Access Compliance Report

Public Rights-of-Way

(Curb Ramps)

Intersection ID: 6928	Main Street: CRAWFORD_DR	Cross Street: PLUMSTEAD_RD	Location: S
ADA ID: 3AE5FDD65D72	Ramp Type: Perp	Initial Pass/Fail: Fail	Overall Compliance: No
Severity Score: 33.75			
Codes/Mitigation Info/Possible Solution		Field Measurements/Component Compliance

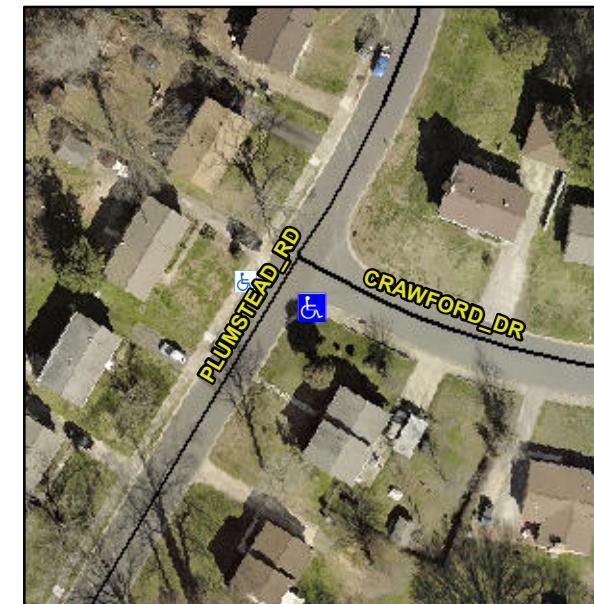
Not Found, R304.5.1, R304.5.3

Compliance	Description	Data	Compliance	Description	Data
N/A	Ramp Length (in)	60.0	Yes	Ramp Slope (%)	7.6
No	Ramp Width (in)	39.0	No	Ramp XSlope (%)	12.6
N/A	Flare Type LT	N/A	N/A	Flare Type RT	N/A
N/A	Flare Slope LT (%)	N/A	N/A	Flare Slope RT (%)	N/A
N/A	Flare Traversable LT?	N/A	N/A	Flare Traversable RT?	N/A
N/A	Landing Length (in)	N/A	N/A	DWS Provided?	N/A
N/A	Landing Width (in)	N/A	N/A	DWS Contrast?	N/A
N/A	Landing Slope (%)	N/A	N/A	DWS Length (in)	N/A
N/A	Landing X Slope (%)	N/A	N/A	DWS Full Width?	N/A
N/A	Landing Curb? (Y/N)	N/A	N/A	DWS Offset (in)	N/A
N/A	Shared Landing?	N/A			
N/A	Gutter Ponding?	N/A	N/A	Gutter Slope (%)	N/A
N/A	Gutter Lip Ht (in)	N/A	N/A	Gutter X Slope (%)	N/A
N/A	Painted X Walk1?	No	N/A	Painted X Walk2?	N/A
	X Walk 1 Direction	To NW		X Walk 2 Direction	N/A
N/A	X Walk 1 Width (in)	N/A	N/A	X Walk 2 Width (in)	N/A
	X Walk 1 Slope (%)	1.0		X Walk 2 Slope (%)	N/A
	X Walk 1 X Slope (%)	6.7		X Walk 2 X Slope (%)	N/A

Remove & Replace Entire Ramp.
